# **Brown Creek Tributaries Restoration Project FINAL Year 7 Monitoring Report/Closeout Report**

DMS Project ID No. 95351  
DEQ Contract No. 004641  
USACE Action ID: SAW-2012-01108  
DWR Project #14-0345  
RFP #16-004108 (Issued 6/20/2011)  
Yadkin River Basin: 03040104-061030

**Subject:** Response to DMS Comments for Task 13 Deliverables: Year 7 Monitoring Report  
Brown Creek Tributaries Restoration Project, Anson County, Yadkin River Basin – CU# 03040104,  
DEQ Contract No. 004641, USACE AID SAW-2012-01108, DMS Project #95351

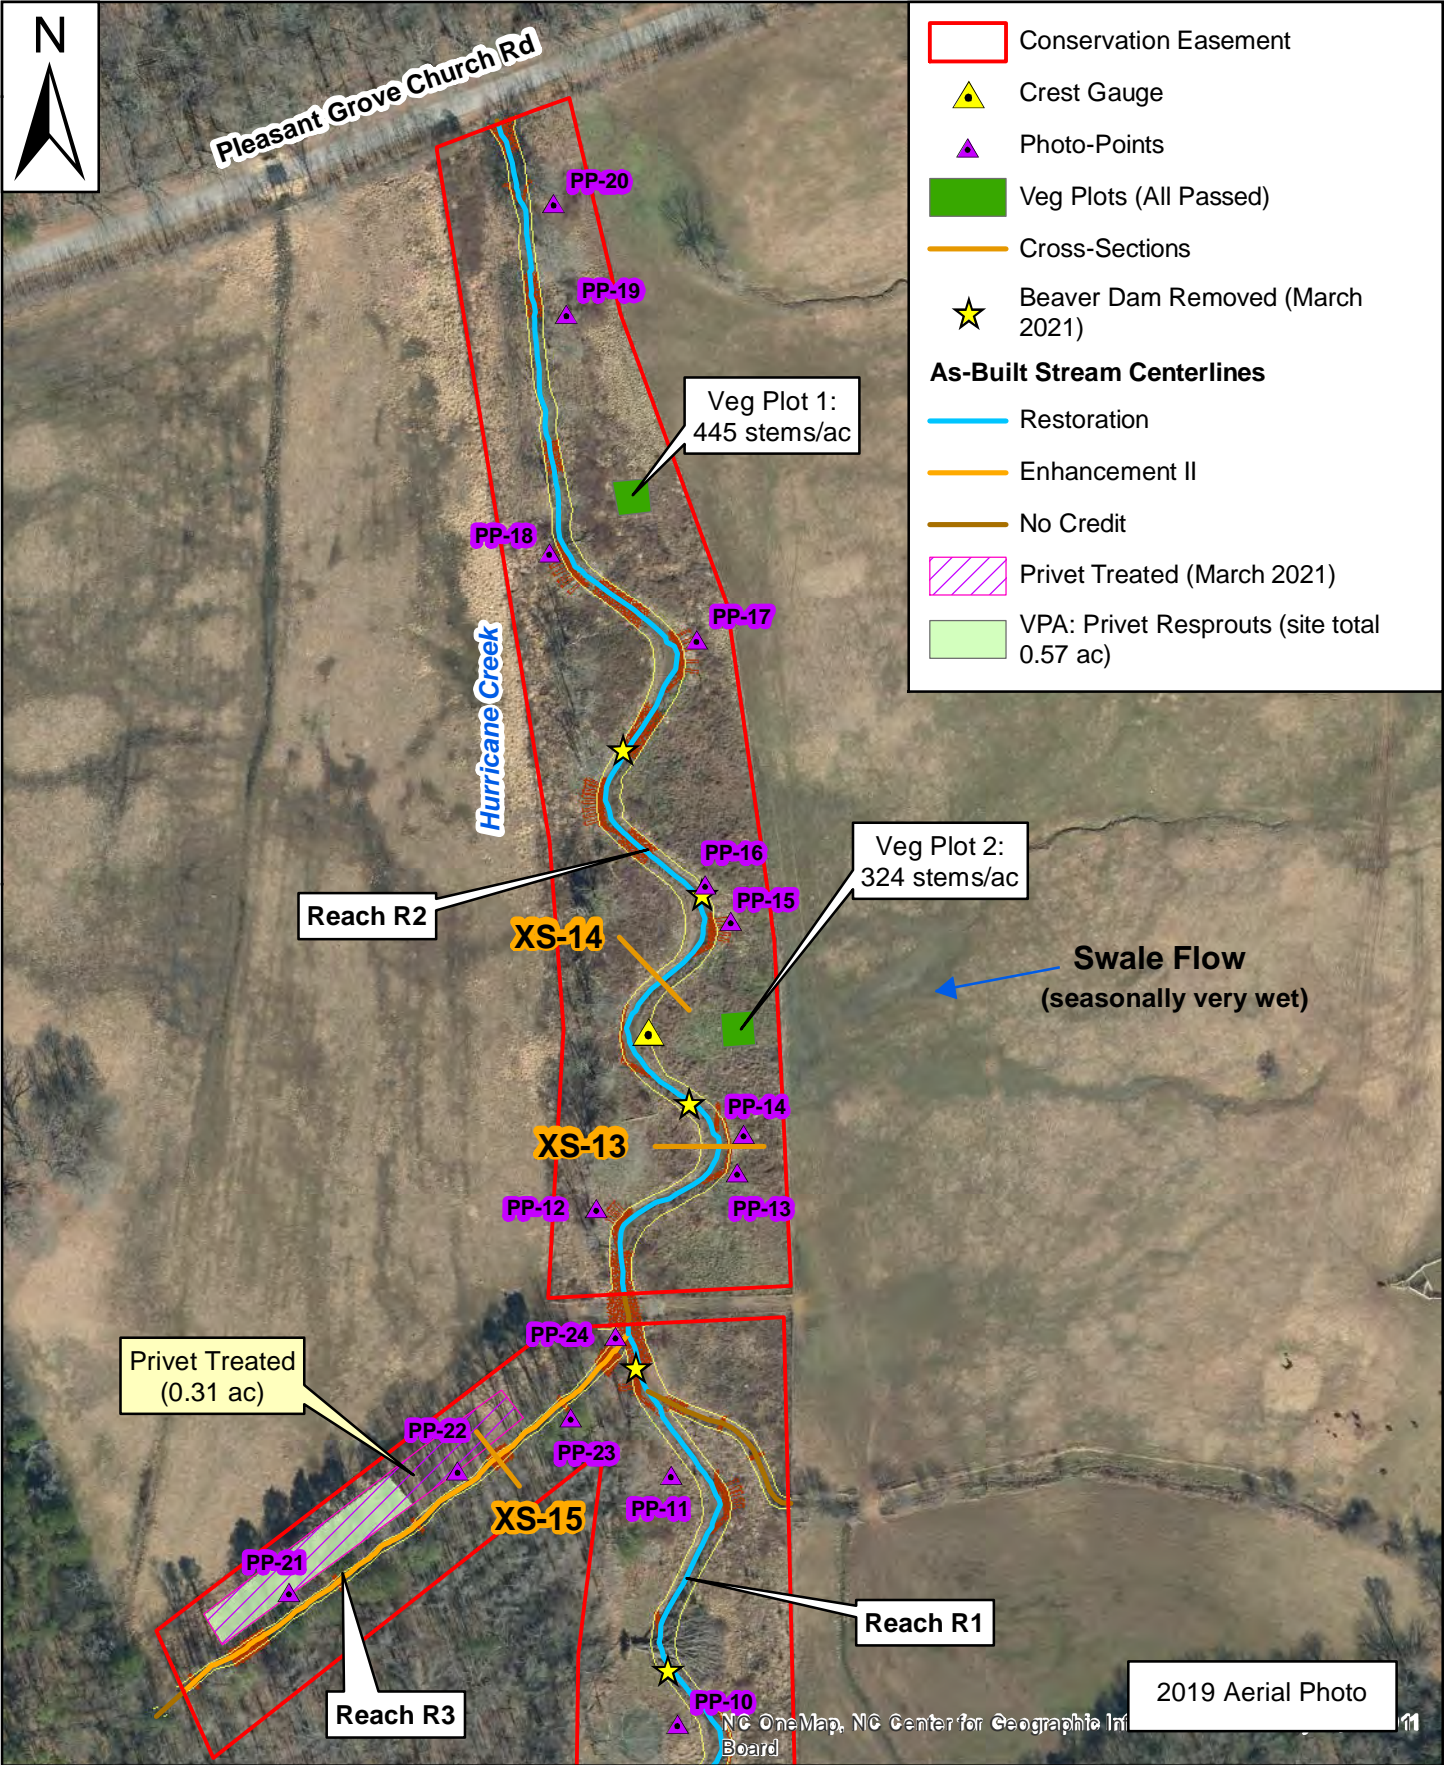
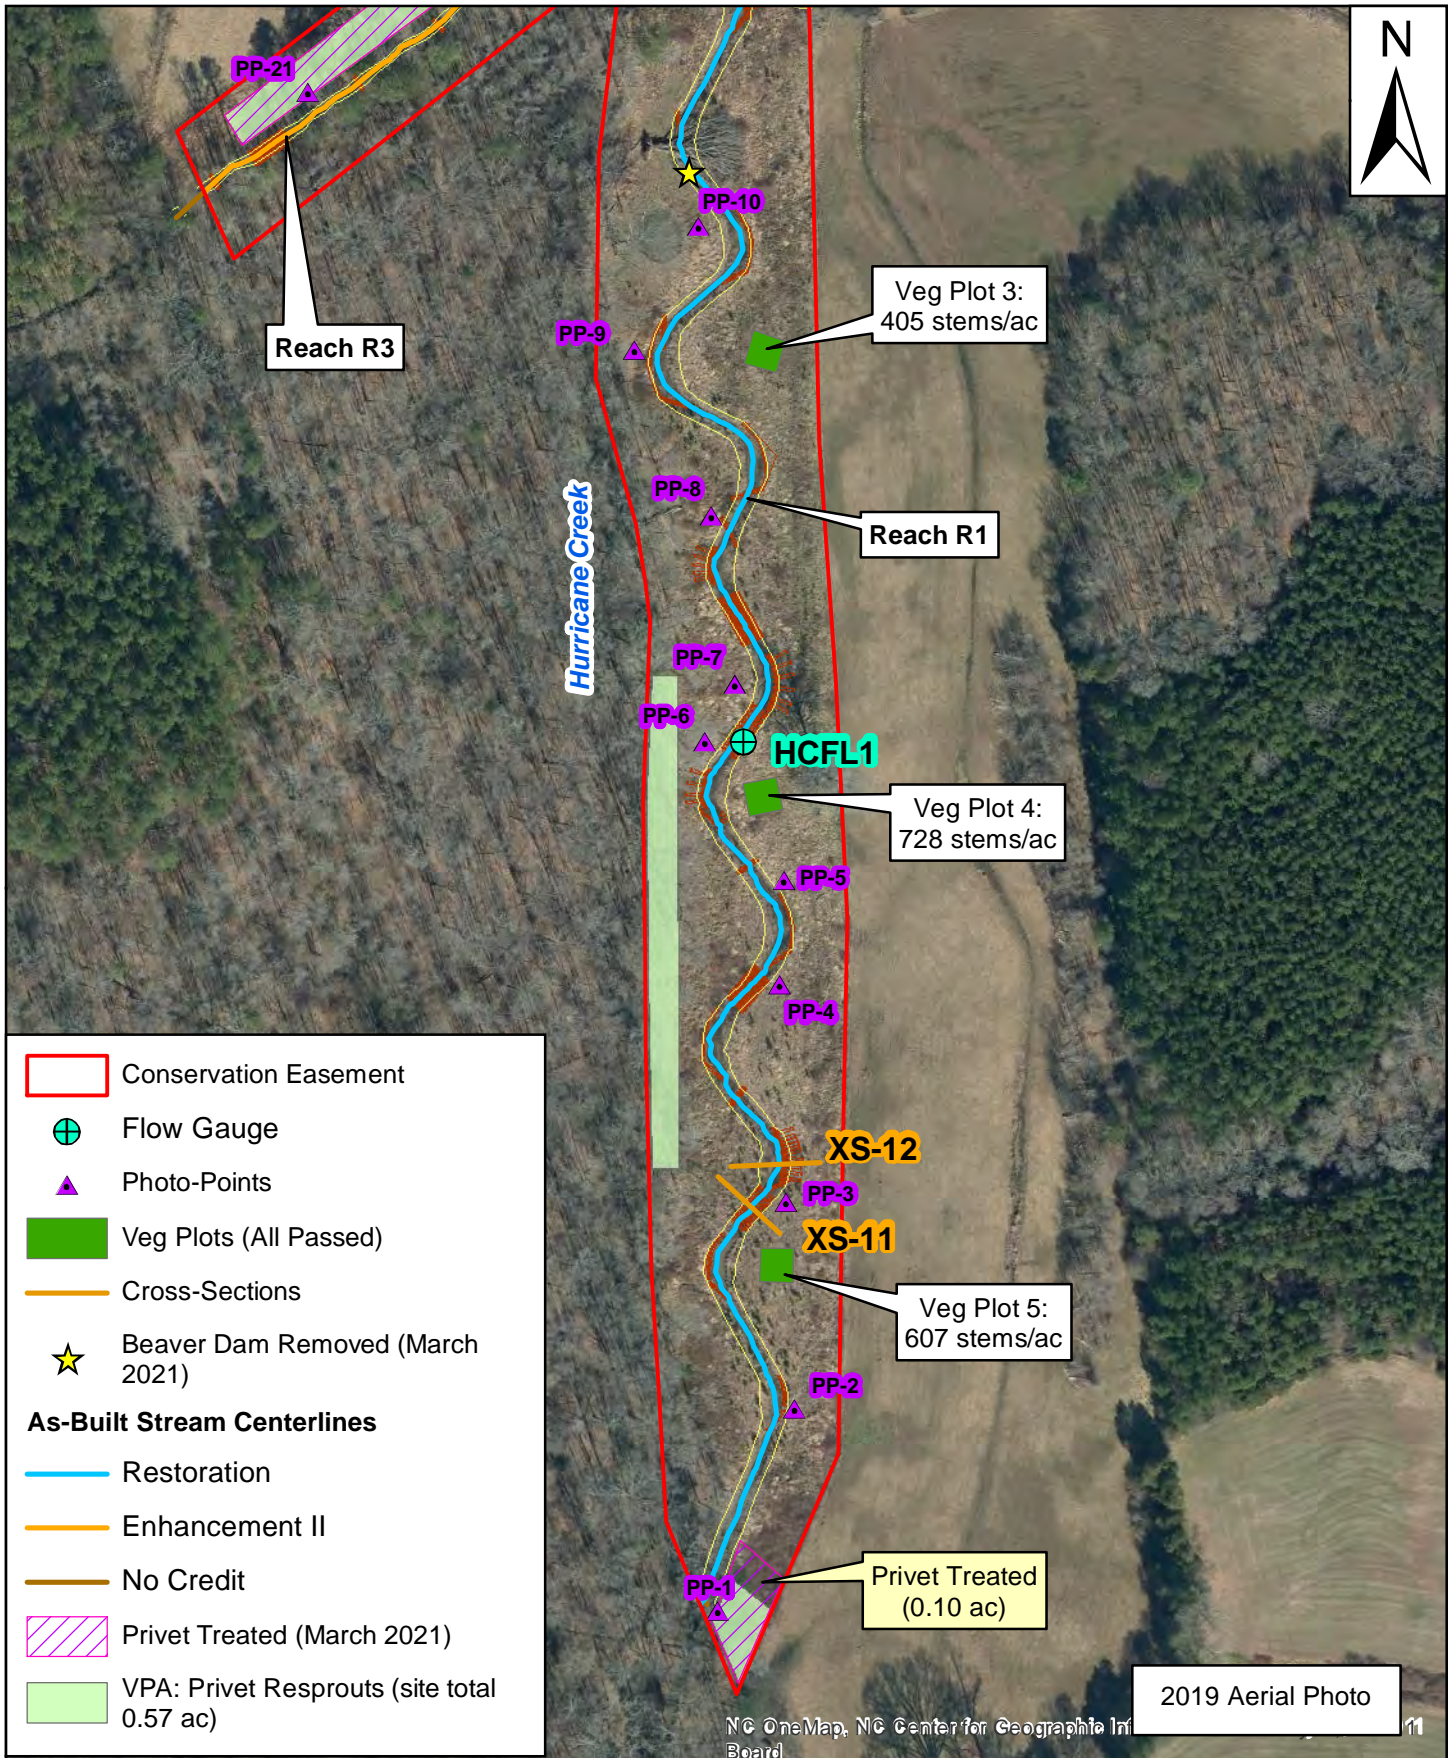
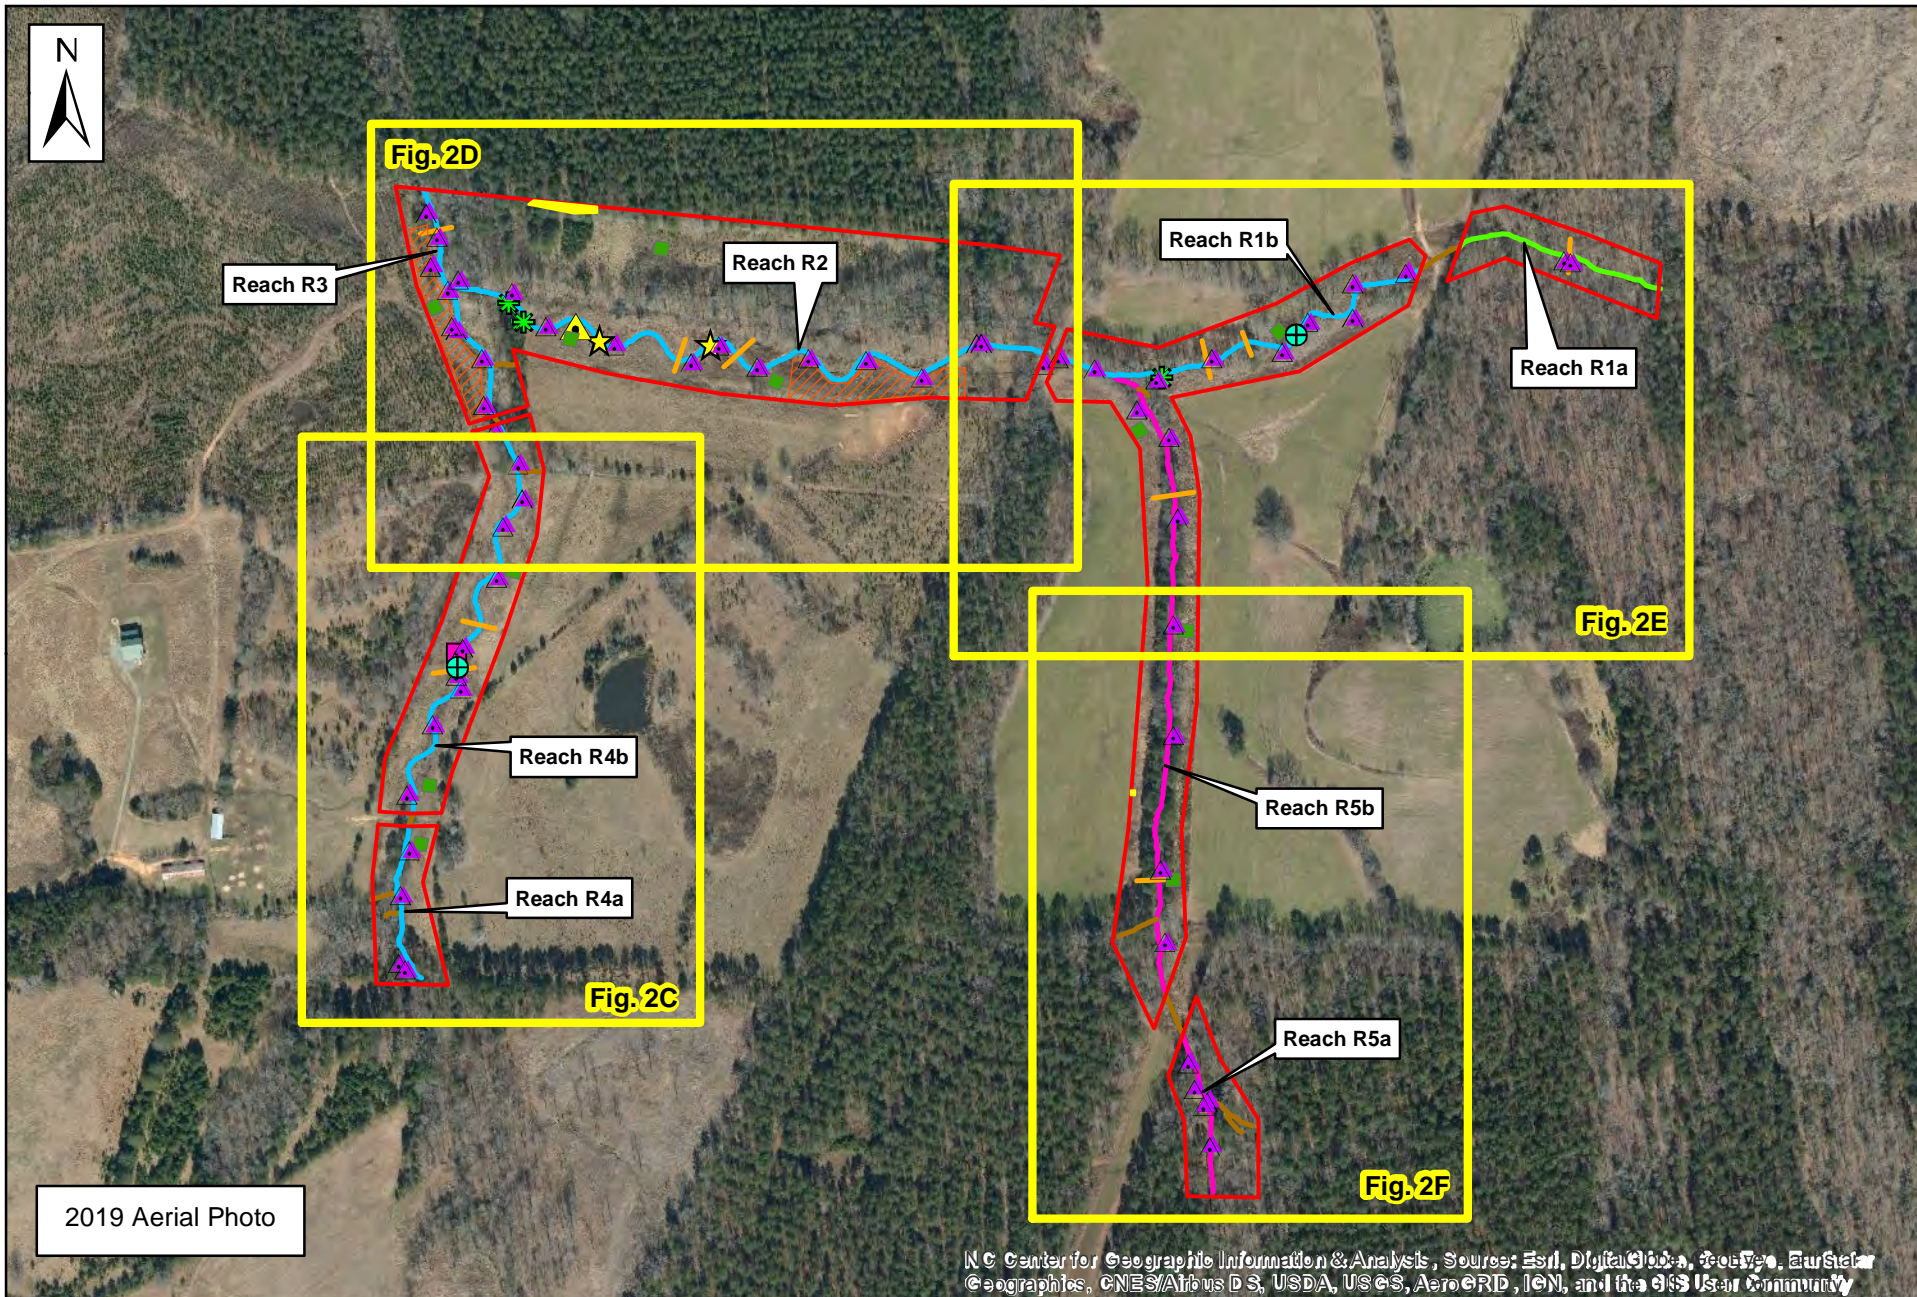
- Figure 2D: Thank you for adding the callout to show the area of pine harvesting within the easement.  
**Response: We appreciate the positive feedback.**
